## MONITORING YEAR 3

### MOORES FORK STREAM MITIGATION PROJECT

Wildlands Engineering, Inc. (Wildlands) has reviewed the Division of Mitigation Services (DMS) comments from the Draft Monitoring Year 3 report for the Moores Fork Stream Mitigation Project. The following Wildlands responses to DMS's report comments are noted in italics lettering.

Figure 3.2 Integrated Current Condition Plan View (Sheet 2 of 6)  
 Moores Fork Stream Mitigation Project  
 DMS Project No. 94709  
 Monitoring Year 3 - 2018  
 Surry County, NC

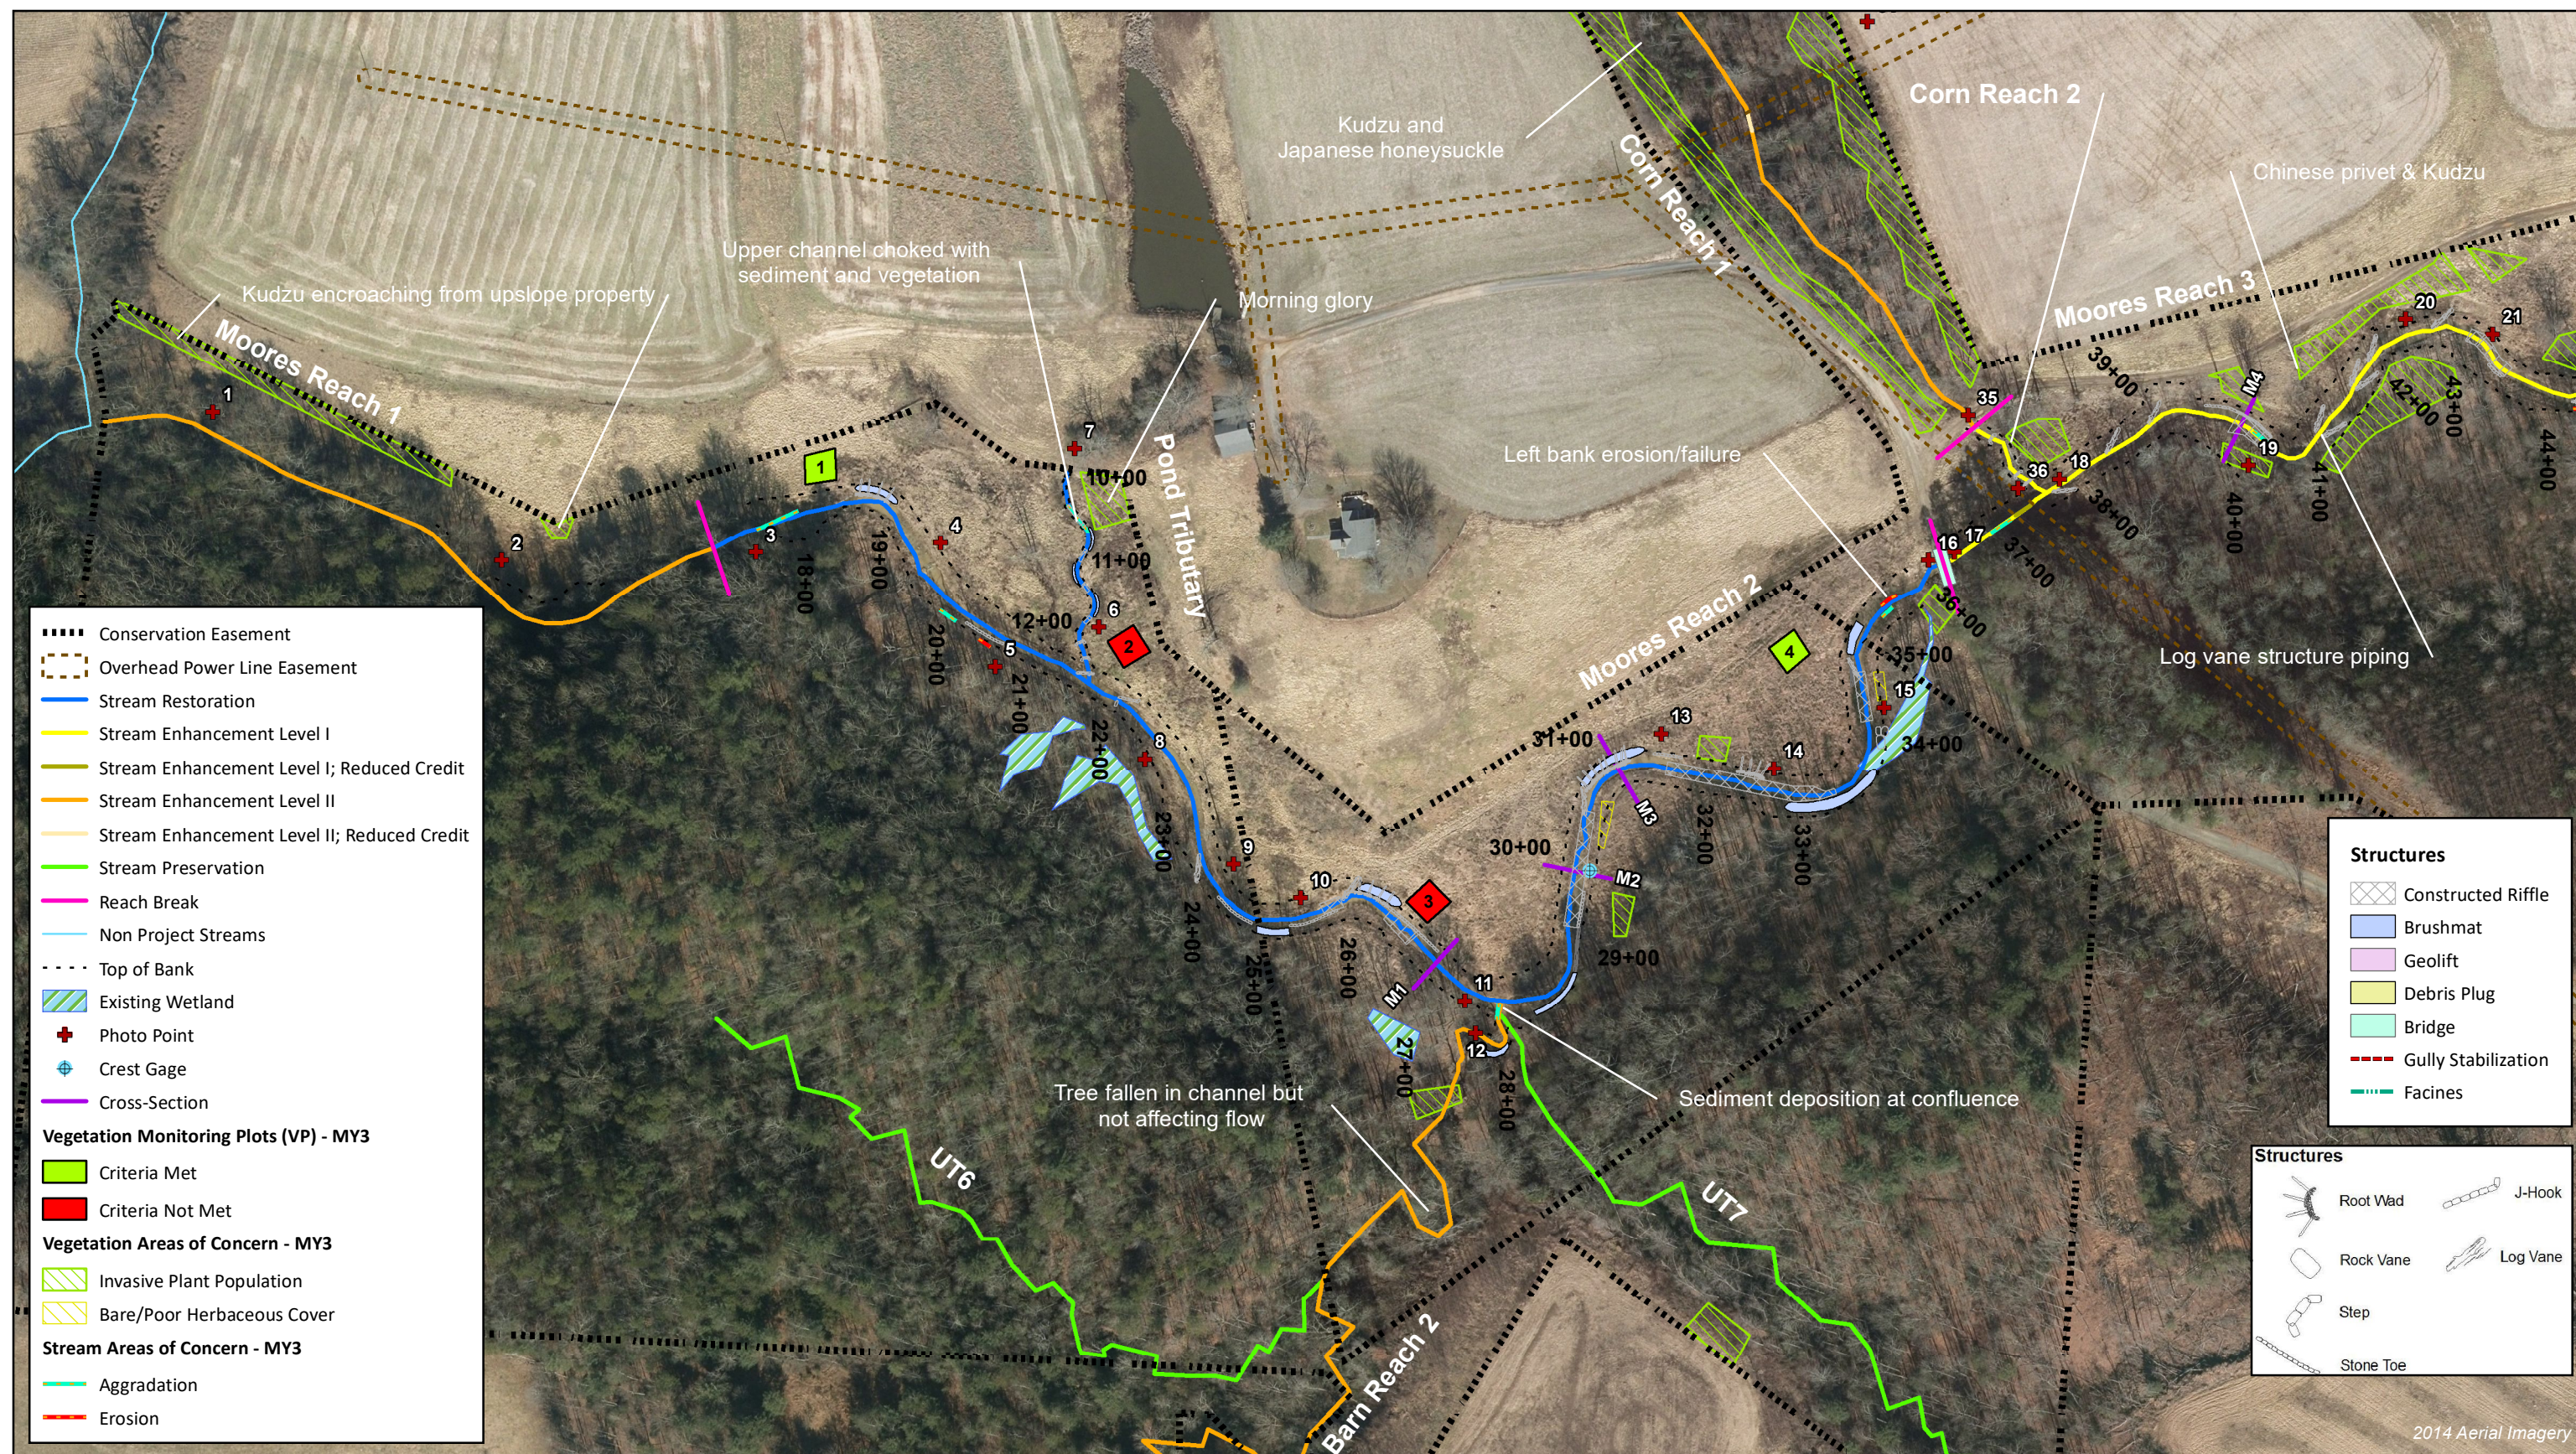
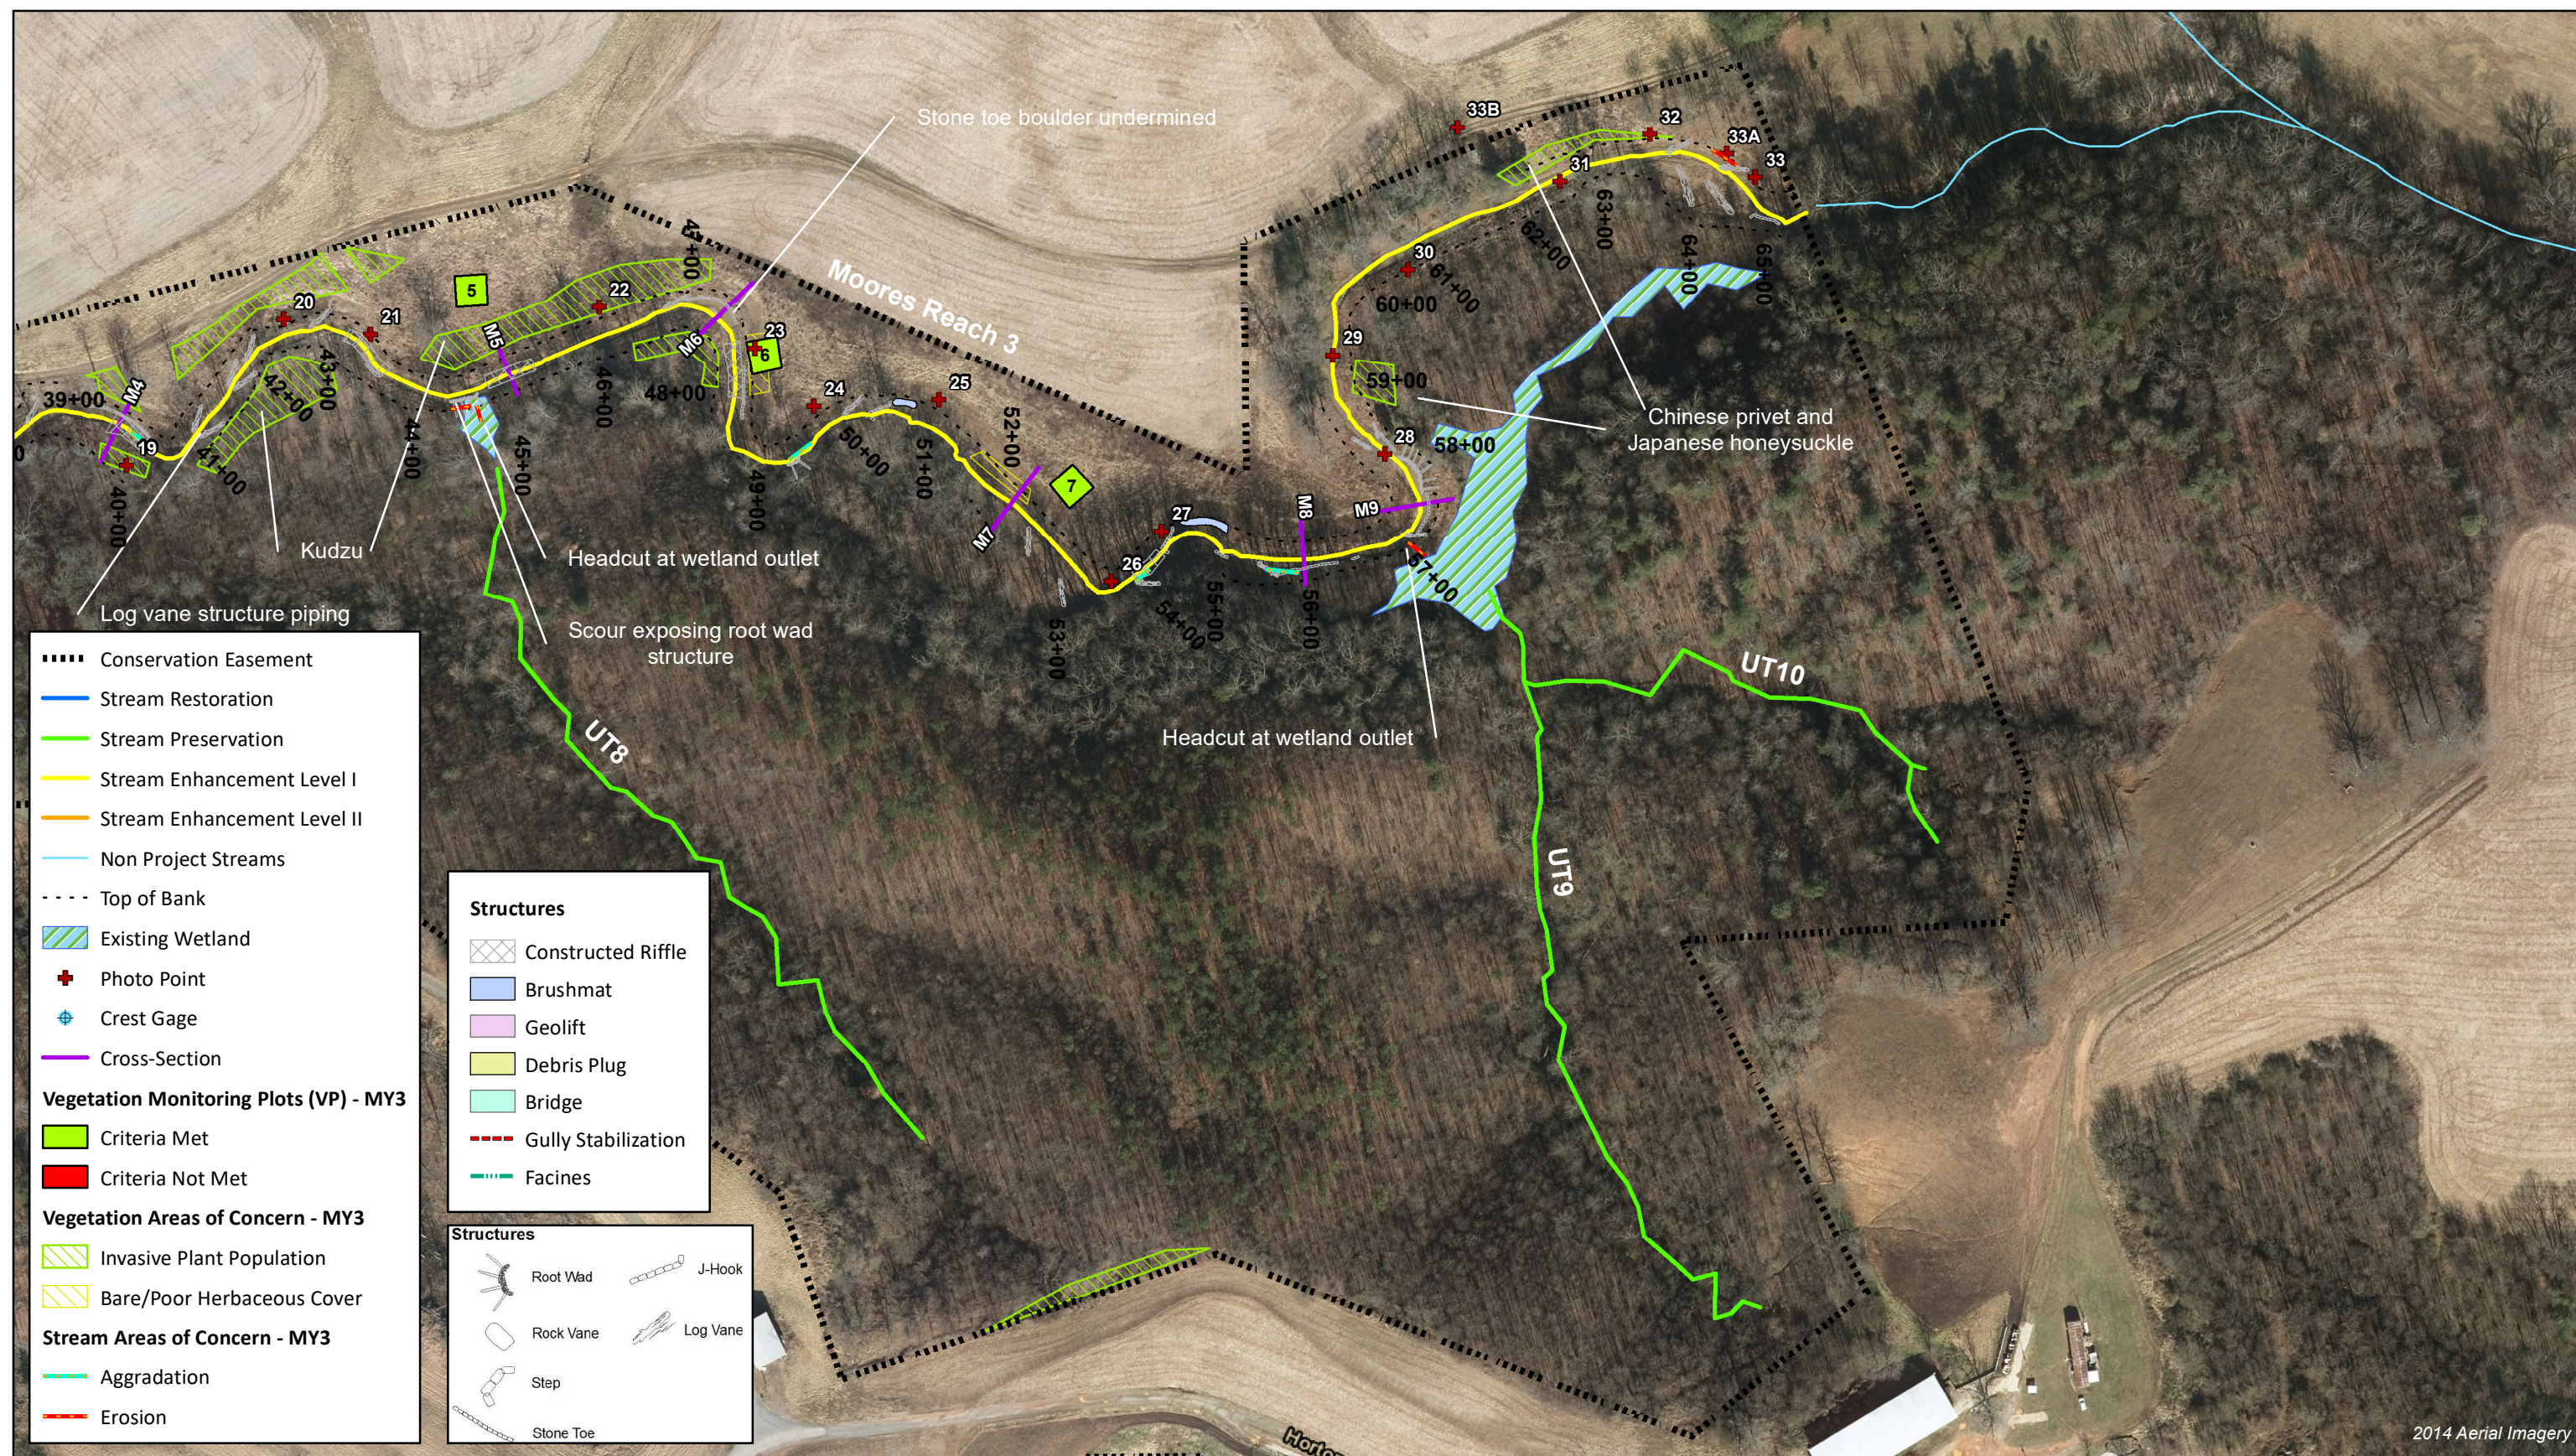
**DMS comment; CCPV: Thanks for providing updated invasive species polygons. Please continue to update as treatment occurs and populations are reduced. This map is a useful tool for the contractor treating the site.**

**DMS comment; CCPV: Please update map with the two additional utility lines.**

**DMS comment; DMS made a site visit on November 26, 2018. We are exploring the possibility of remedial action to some areas depicted on the CCPV as being problem areas. DMS will coordinate with Wildlands when final decisions have been made.**

*Wildlands response; Wildlands will continue to update the CCPV figures as treatment of invasive species occurs and populations are reduced.*

*Wildlands response; The CCPV figures have been updated with the additional utility lines crossing on Moores Fork and Corn Trib.*

*Wildlands response; Thank you for this information. Wildlands will look for communication from DMS about possible remedial action to some areas of concern depicted on the CCPV.*
